CHPE EM&CP

Segment 8 (Package 5A) EM&CP Appendix J Memo – NDC-0049

HDD Report Revision Memo for HDD Design Change

Design Change Number(s): NDC-0049

Deviation Zone Analysis

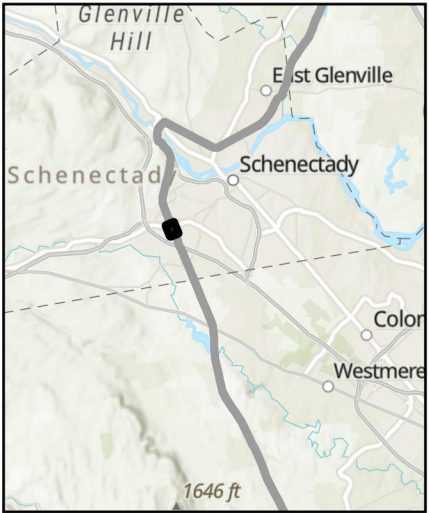
NDC-0049 extends HDD 73 to exit in the southern parking lot of the Golub property. Additionally, the alignment has been designed to maintain a minimum 12ft offset from the Duanesburg Road bridge abutment.
